FINAL REPORT

ARIZONA CANAL DIVERSION CHANNEL AESTHETICS COMMITTEE

MAY 5, 1989

RE: Transmittal of ACDC Aesthetics Committee Final Report
for Review and Comment

Figure 3. HIGH PRIORITY AREAS: DECKING

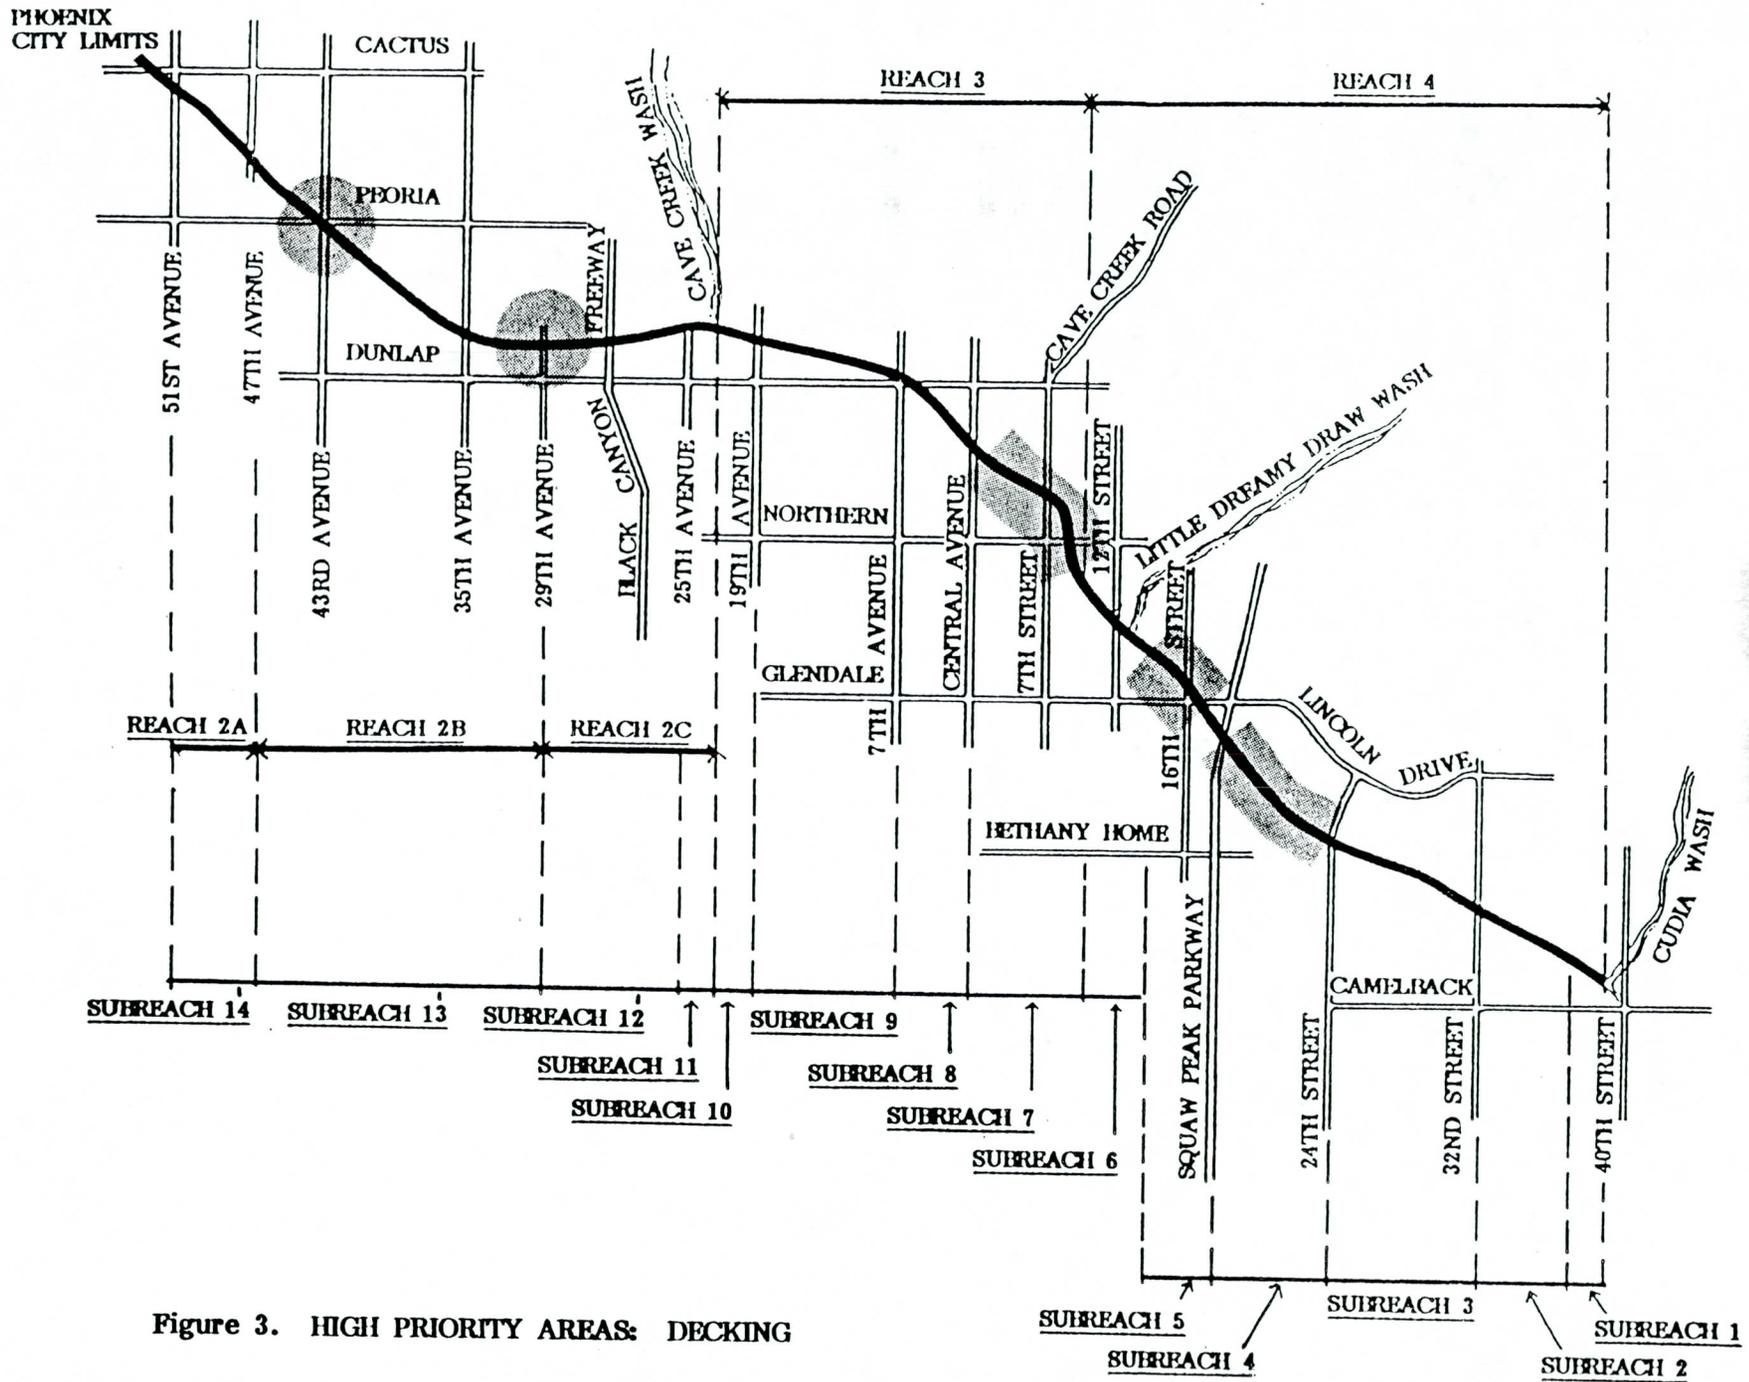
Based on stated objectives and guidelines and on extensive fieldwork by Committee members, the following areas have been identified as having highest priority for decking of the ACDC (Figure 3):

Figure 4. UNDERPASS ACCESS FOR BICYCLISTS FROM INTERSECTING STREETS

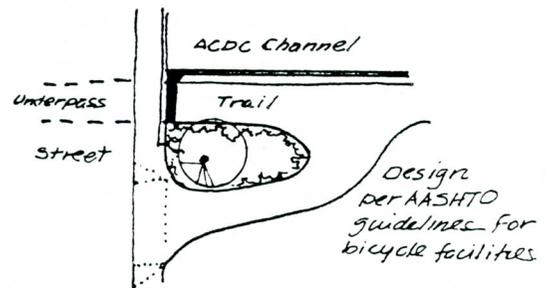
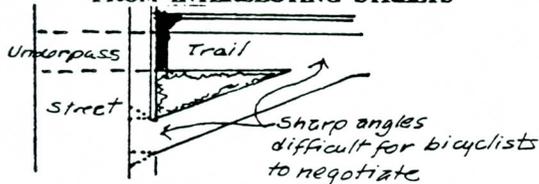
3.2.3. Access to underpasses for trail users coming to the ACDC trail from intersecting streets must be designed to AASHTO standards. In particular, adequate horizontal turning radii for reasonable bicycle design speeds must be provided where a trail leading to a street joins the ACDC trail (see Figure 4).

- o Underpass trail approaches must be designed (or retrofitted if already constructed) to provide adequate turning radii for bicyclists turning onto the ACDC trail from intersecting streets (Figure 4).

The underpass constructed at 35th Avenue needs only minor improvements: the drainage grate installed in the bottom of the underpass has parallel slats and is not installed flush with the pavement; and turning radii between the 35th Avenue access trail and the underpass are inadequate. If a bicyclist wishes to ride from 35th Avenue down to the ACDC trail underpass, he/she must negotiate an almost unrideably sharp turn at the intersection of the ACDC trail and the trail leading up to 35th Avenue (Figure 4, following p. 26).

Figure 5. TRAIL RAMP DESIGN

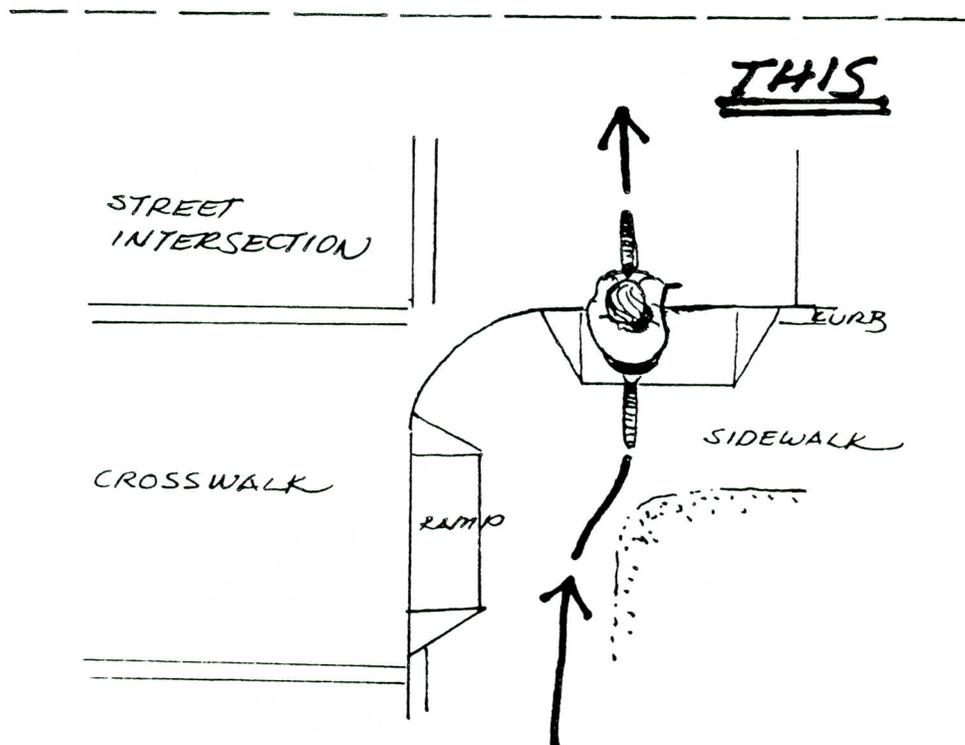
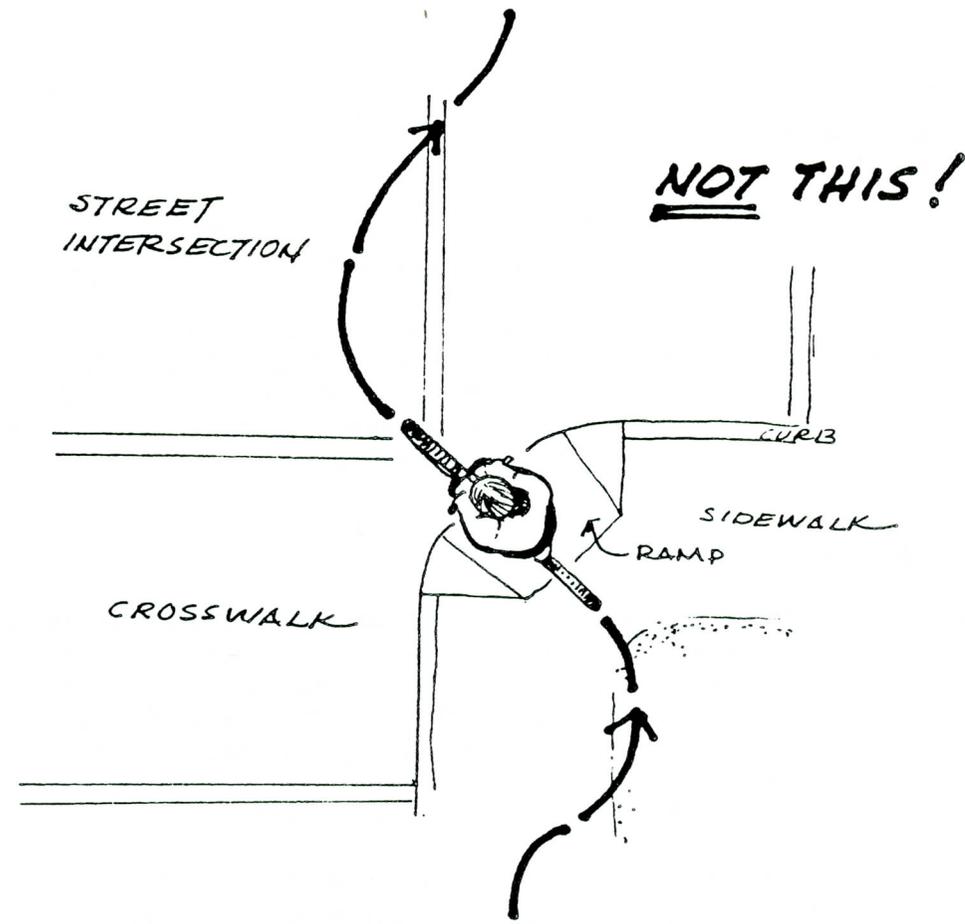
- o Utility poles or boxes, fire hydrants, and similar obstructions should be relocated from the path.
 - o Ramp designs should be modified if necessary so trail users can travel straight across the street rather than be forced to angle out into the intersection (see Figure 5).

Figure 8. REACH 2A: GLENDALE CITY LIMITS TO 47TH AVENUE (SUBREACH 14)

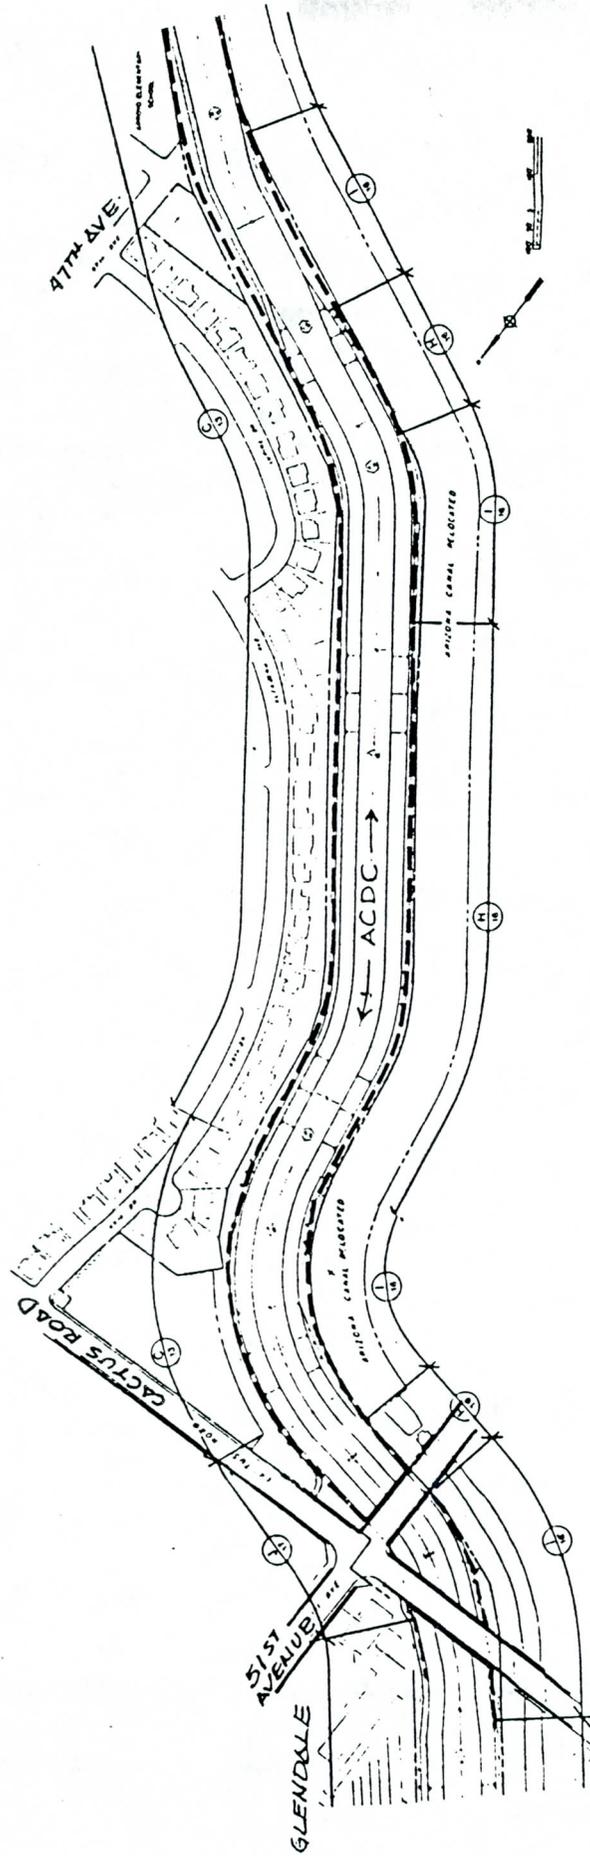
2. Retrofit both ACDC bridges to meet AASHTO and other standards acceptable to all user groups; improve access to the bridges as discussed in A.l.c. (both from area streets via Arizona Canal bridge and from ACDC trail to the bridges); install appropriate warning and directional signage; replace barrier gates on the 51st Avenue trail and the Cactus Road north ACDC maintenance road with gates or bollards that allow free trail user access; implement recommendations in A.l.c.

3. Provide signage directing trail users to cross the pedestrian bridge at 47th Avenue to the north side of the Channel; replace the bridge with one usable by equestrians; construct a trail along the north side of ACDC from 47th Avenue to 51st Avenue/Cactus Road, to be used for intersection crossing (this eliminates trail use of the 51st Avenue bridge); open up trail access to the north ACDC maintenance road behind the 7-11 store, replacing the security gate with one that allows free trail access and providing other improvements for trail users (e.g., put curb or other barrier next to drainage gutter on north side of road); retrofit Arizona Canal

bridge to provide wider sidewalk and ramps; install barrier and warning/directional signs at 51st Avenue; replace 51st Avenue gate with one that allows free trail access; angle trail to create acceptable horizontal radius for bridge access at 51st Avenue.

Figure 9. REACH 2B 47TH AVENUE TO 29TH AVENUE
(SURREACH 13)

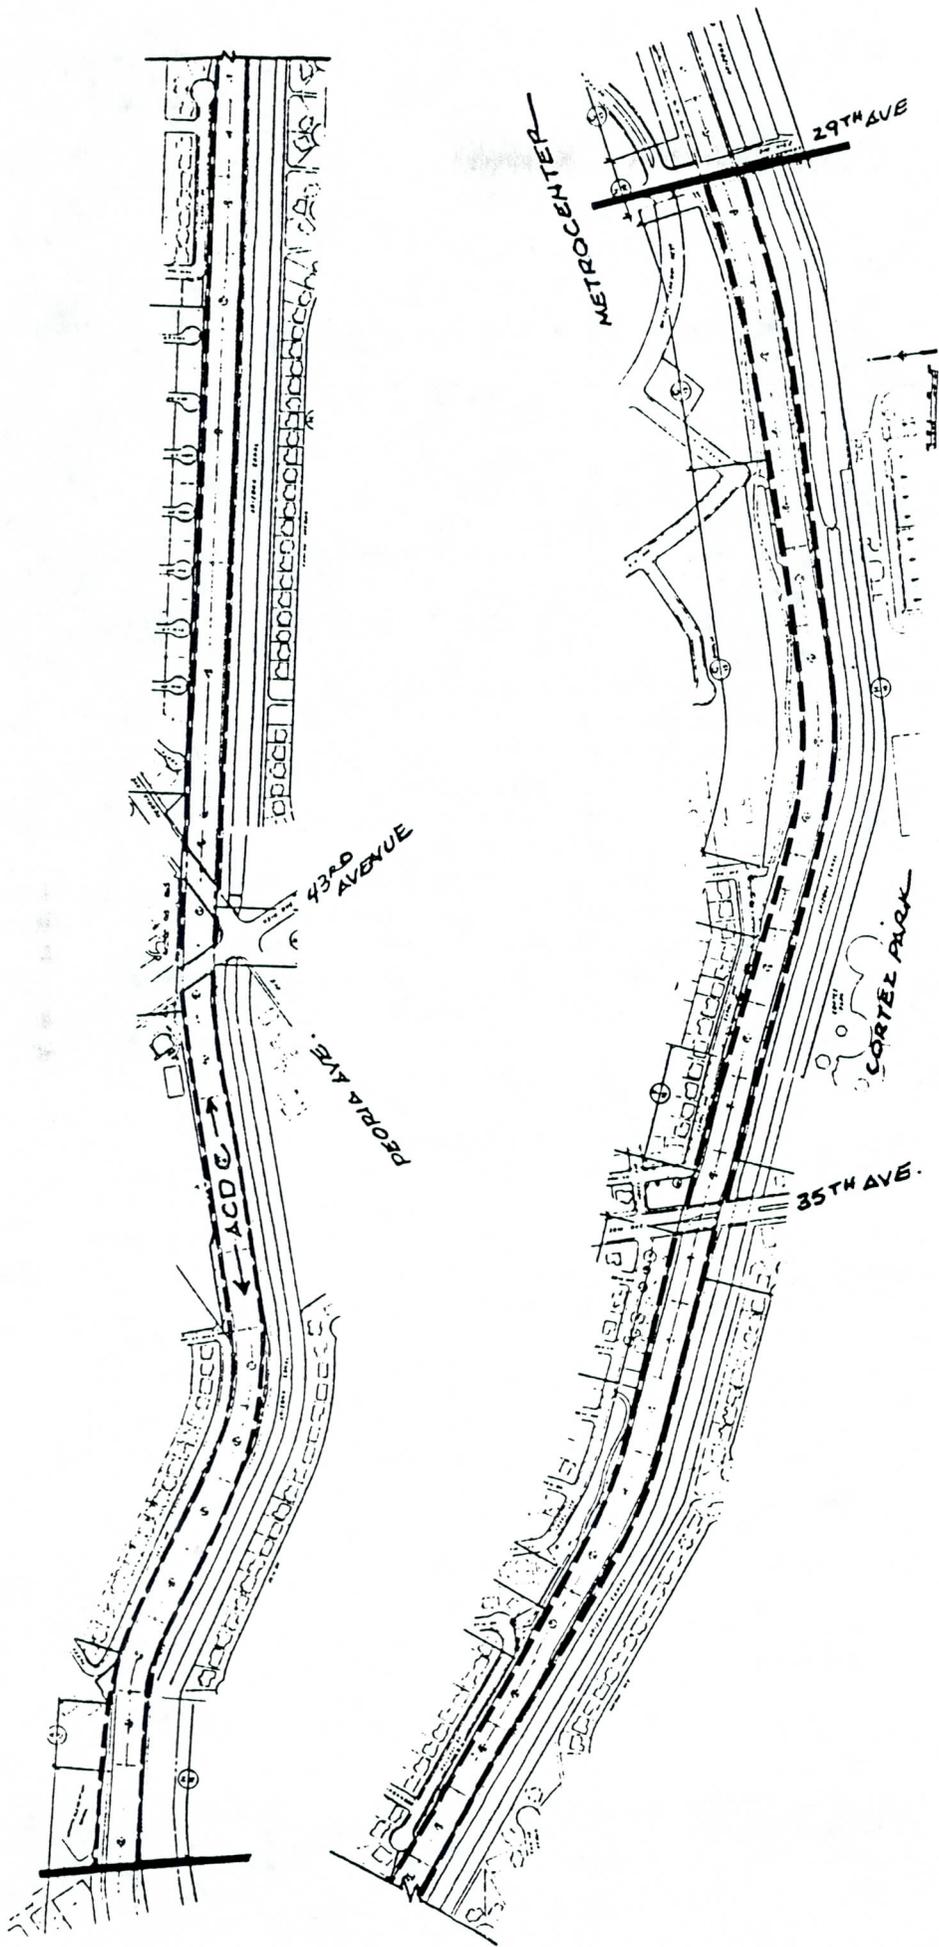
1. Increase plant sizes and numbers where homes face the ACDC and where landscape nodes are planned. Provide significant upgrades, especially in front of visual barrier walls on streets such as Carol and Malapai. Re-examine the types of plant materials used and make any adjustments needed to provide hardy plants that will survive freezes and summer heat with minimal maintenance.
2. Explore the possibility of public art projects, neighborhood "gateways" or distinctive landscape character at the following locations:

- o 43rd Avenue/Peoria (northwest, northeast corners)
 - o Landscape node at Malapai/37th Drive
 - o 35th Avenue (northwest, northeast corners)
 - o Carol Avenue/33rd Avenue

5. Add staggered visual barrier wall sections as shown in Figure 10 and connect them with wrought iron panels. Provide maintenance gates in the wrought iron panel sections, as needed. Keep walls as far away from curb as possible, while providing the required offset in wall alignments.

Figure 10. VISUAL BARRIER WALL TREATMENT

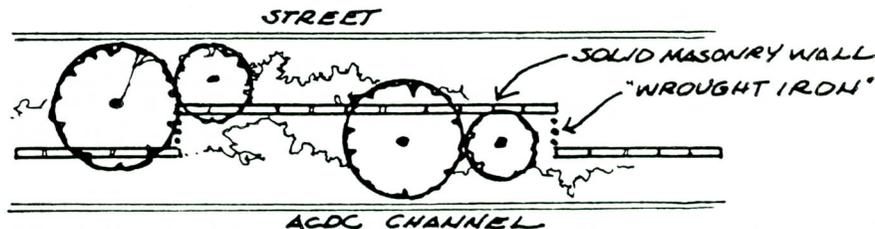
- o Original design concepts for the visual barrier wall presented to the neighborhoods called for staggering wall sections to screen ACDC from view by adjoining homeowners while providing visual interest with the varied wall alignment (see Figure 10).

Neighbors indicate that they strongly prefer this staggered alignment, with wrought iron fencing connecting the wall panels as indicated above. The wall as constructed does not provide screening. Even a continuous, solid wall is preferable to the wall that is now in place.

5. Add staggered visual barrier wall sections as shown in Figure 10 and connect them with wrought iron panels. Provide maintenance gates in the wrought iron panel sections, as needed. Keep walls as far away from curb as possible, while providing the required offset in wall alignments.

Figure 12. REACH 2D: 25TH AVENUE TO CAVE CREEK WASH/REACH 3 BOUNDARY (SUBREACH 11)

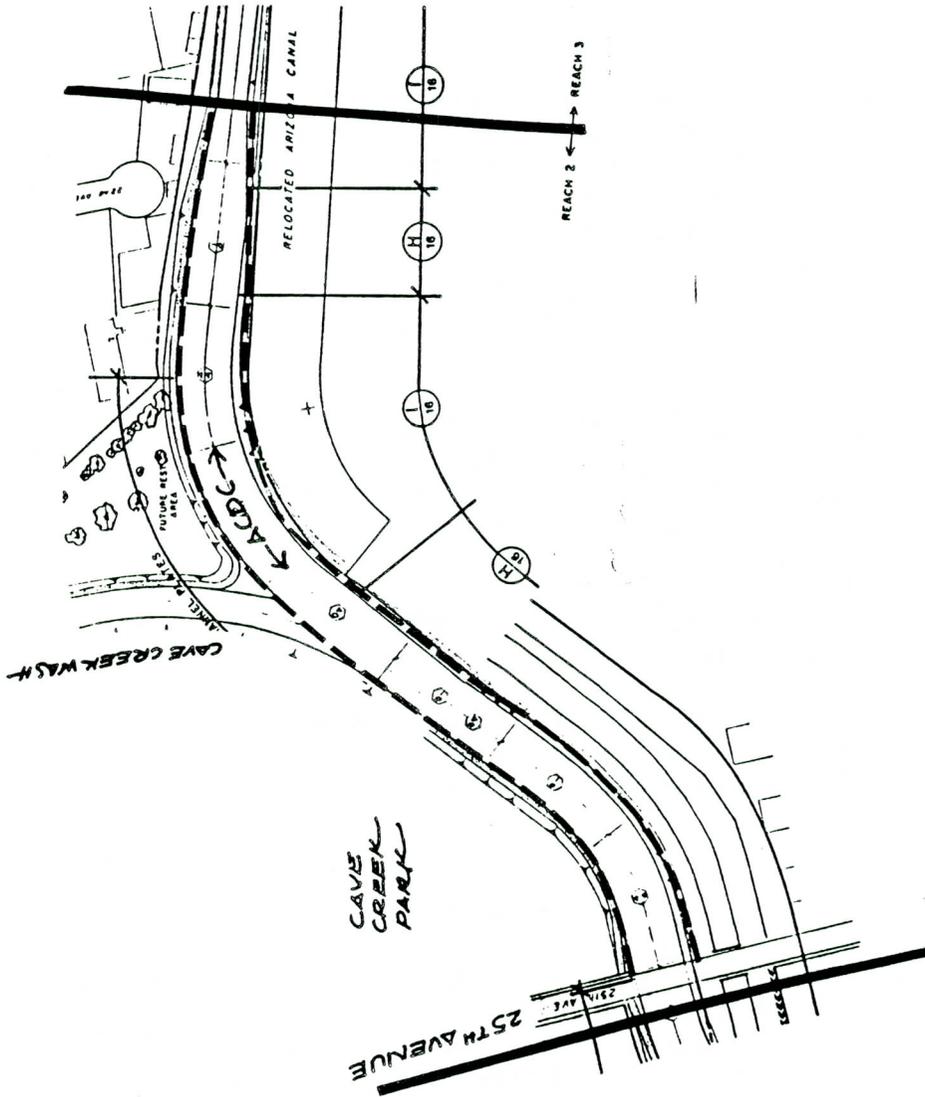
1. Design and construct the intersection of the ACDC trail and the Cave Creek Wash trail to achieve safety and trail continuity for all trail users. As a guide use AASHTO standards for bicycle facilities and other generally accepted standards for equestrian facilities.
2. Provide trail lighting throughout this subreach, adequate for trail illumination and security.
